Access Compliance Report

Public Rights-of-Way

(Curb Ramps)

Intersection ID: 29983	Main Street: REAMES_RD	Cross Street: SILVER_GARDEN_LN	Location: SE
ADA ID: 5A7E14244D63	Ramp Type: Perp	Initial Pass/Fail: Fail	Overall Compliance: No
Severity Score: 21.25			
Codes/Mitigation Info/Possible Solution		Field Measurements/Component Compliance

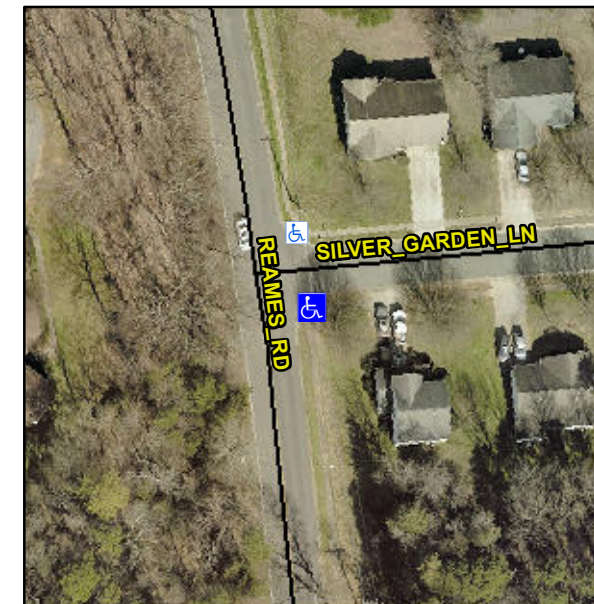
R304.5.1, R304.2.2

Compliance	Description	Data	Compliance	Description	Data
N/A	Ramp Length (in)	48.0	No	Ramp Slope (%)	11.5
No	Ramp Width (in)	47.3	Yes	Ramp XSlope (%)	0.6
N/A	Flare Type LT	N/A	N/A	Flare Type RT	N/A
N/A	Flare Slope LT (%)	N/A	N/A	Flare Slope RT (%)	N/A
N/A	Flare Traversable LT?	N/A	N/A	Flare Traversable RT?	N/A
N/A	Landing Length (in)	N/A	N/A	DWS Provided?	N/A
N/A	Landing Width (in)	N/A	N/A	DWS Contrast?	N/A
N/A	Landing Slope (%)	N/A	N/A	DWS Length (in)	N/A
N/A	Landing X Slope (%)	N/A	N/A	DWS Full Width?	N/A
N/A	Landing Curb? (Y/N)	N/A	N/A	DWS Offset (in)	N/A
N/A	Shared Landing?	N/A			
N/A	Gutter Ponding?	N/A	N/A	Gutter Slope (%)	N/A
N/A	Gutter Lip Ht (in)	N/A	N/A	Gutter X Slope (%)	N/A
N/A	Painted X Walk1?	No	N/A	Painted X Walk2?	N/A
	X Walk 1 Direction	To N		X Walk 2 Direction	N/A
N/A	X Walk 1 Width (in)	N/A	N/A	X Walk 2 Width (in)	N/A
	X Walk 1 Slope (%)	2.9		X Walk 2 Slope (%)	N/A
	X Walk 1 X Slope (%)	3.2		X Walk 2 X Slope (%)	N/A

Remove & Replace Entire Ramp.
